ROBINSON HELICOPTER COMPANY

R66 SERVICE BULLETIN SB-42

SUBJECT: Auxiliary Fuel Flow Sensor Circuit

ROTORCRAFT AFFECTED: R66 Helicopters S/N 0670, and 0719 thru 1319, except 1292 and 1315, equipped with Auxiliary Fuel System.

FIGURE 1
(VIEW LOOKING DOWN)

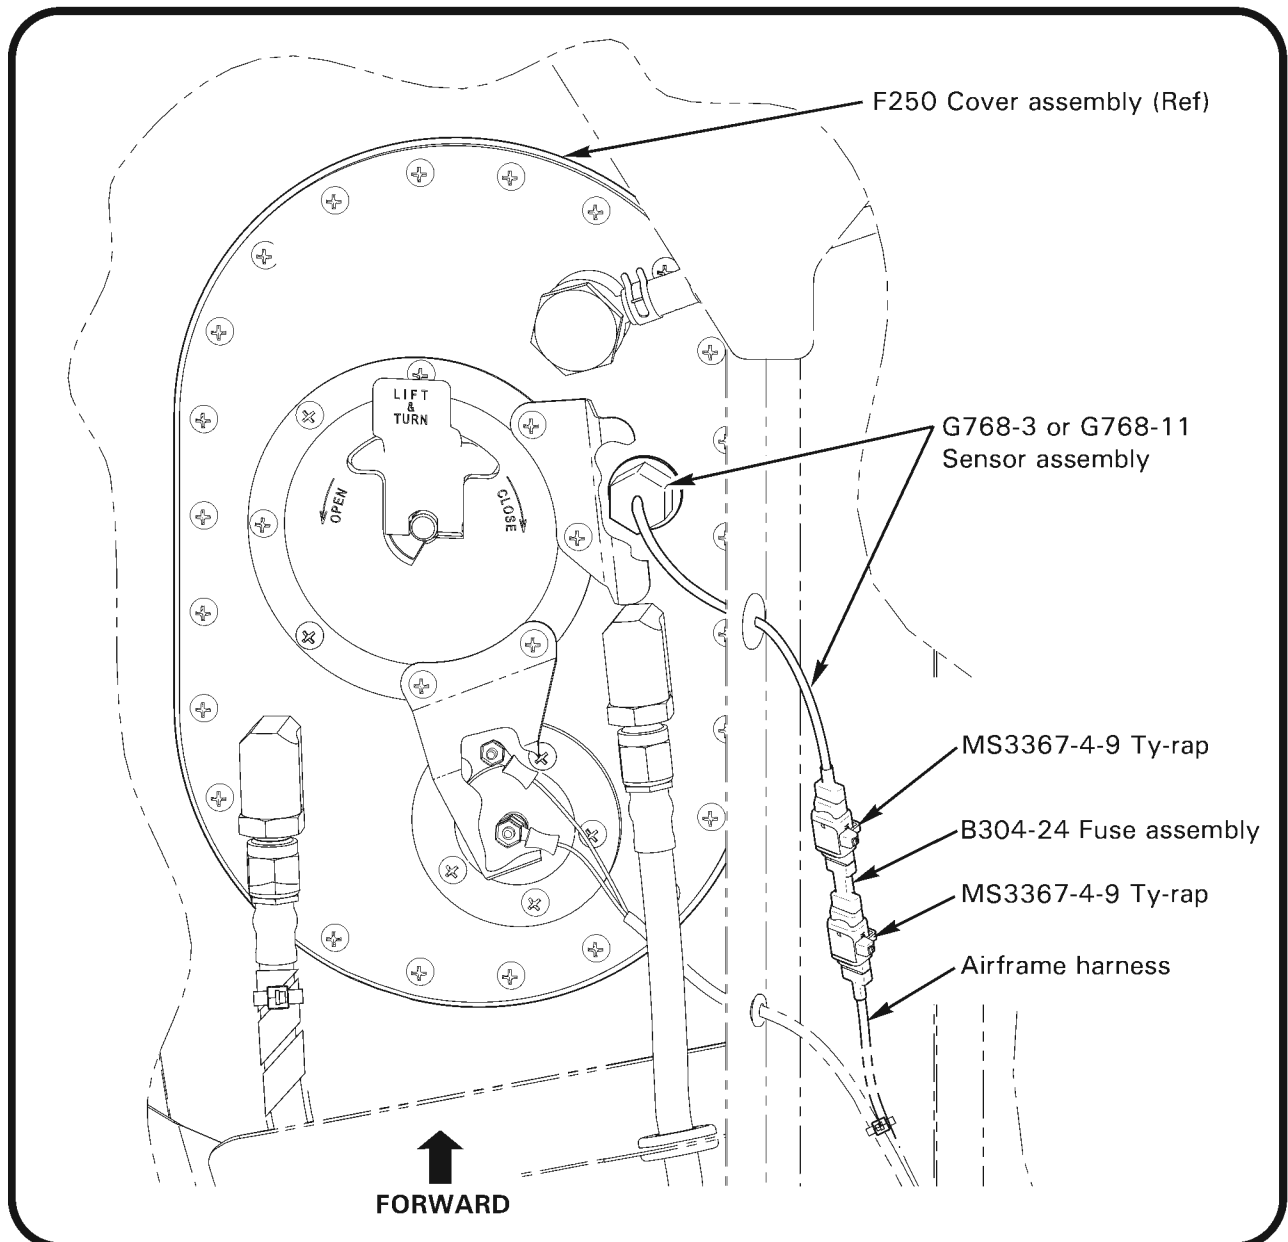
BACKGROUND: RHC has determined that a fault within the auxiliary fuel flow sensor circuit may lead to an unsafe condition. This bulletin requires installing a fuse assembly to reduce the maximum current that can be supplied to the sensor.

4. Refer to Figure 1. Cut and discard ty-rap and disconnect G768-3 or G768-11 sensor assembly from airframe harness at connectors. Verify no damage to harness portion of sensor; replace sensor as required.

5. Connect B304-24 fuse assembly to sensor & airframe harness at connectors, and install MS3367-4-9 ty-raps as shown. Cinch ty-raps until snug without overtightening and trim tips flush with heads.
